W3F1-2010-0019

Subject: Technical Specification Table 3.4-1 Isolation Valve Addition
Waterford Steam Electric Station, Unit 3
Docket No. 50-382
License No. NPF-38

Analysis of Proposed Technical Specification Change

Figure 1. Shutdown Cooling Suction Bypass Line

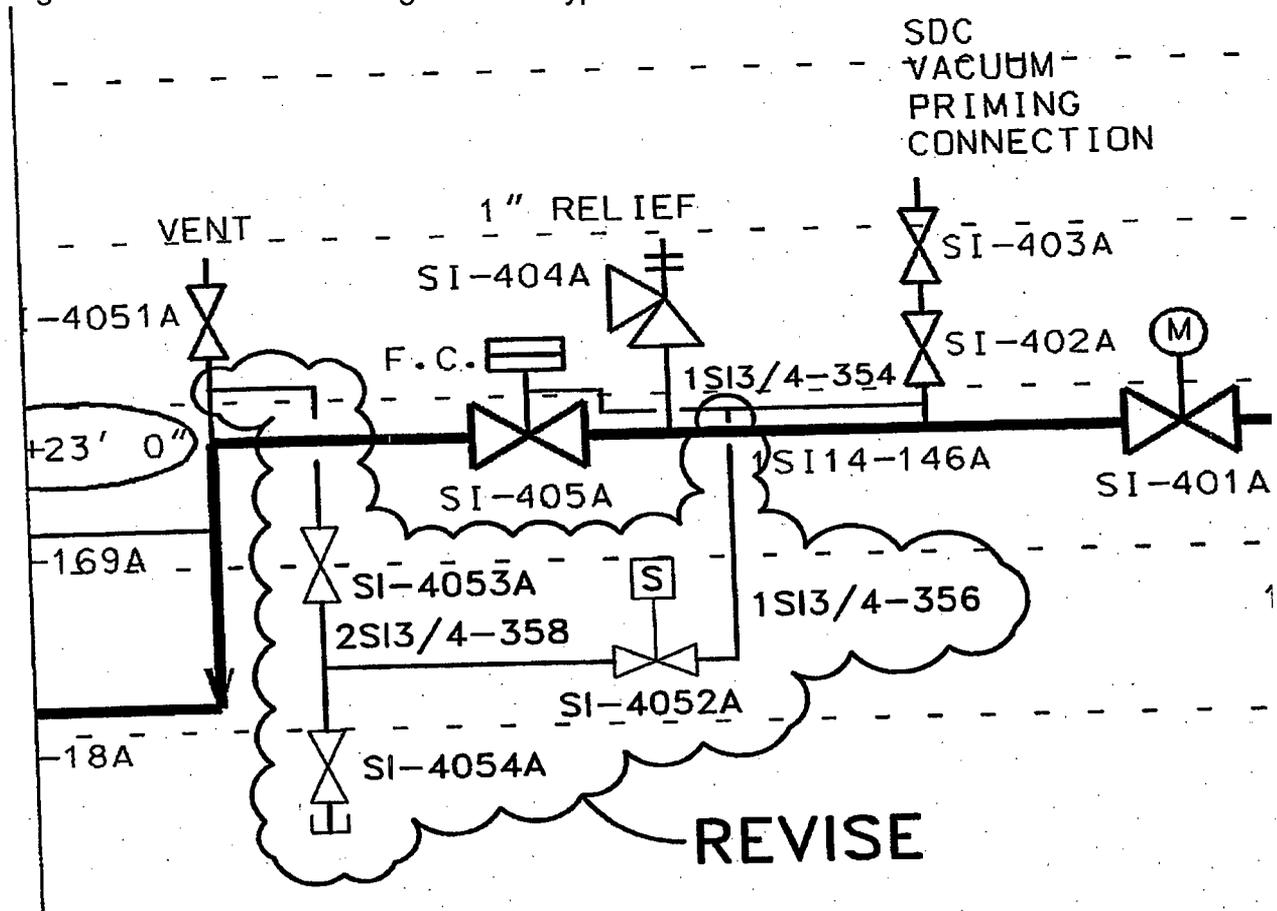
SI-4052A(B) will be solenoid valves installed to bypass shutdown cooling isolation valve SI-405A (RC LOOP 2 SDC SUCTION INSIDE CONTAINMENT ISOL) and SI-405B (RC LOOP 1 SDC SUCTION INSIDE CONTAINMENT ISOL), respectively. The purpose of this line is to equalize the shutdown cooling system pressure down stream of valves SI-405A(B) in order to minimize the pressure transient in the system when valves SI-405A(B) are opened.

Figure 1 shows the new valves and line configuration. Figure 1 is specifically for the "A" train; the "B" train is a similar configuration.

The new line will create a bypass around valves SI-405A(B) to minimize the void formed during the plant operating cycle downstream of SI-405A(B) before SI-405A(B) is opened. The solenoid valves, SI-4052A(B), which will be installed in parallel with valves SI-405A(B) will be part of the class boundary separating class 1 and class 2 piping and are identified as a containment isolation valves.

The new bypass line will require 2 supports at the new solenoid valves SI-4052A(B) at the vertical class 2 piping run.
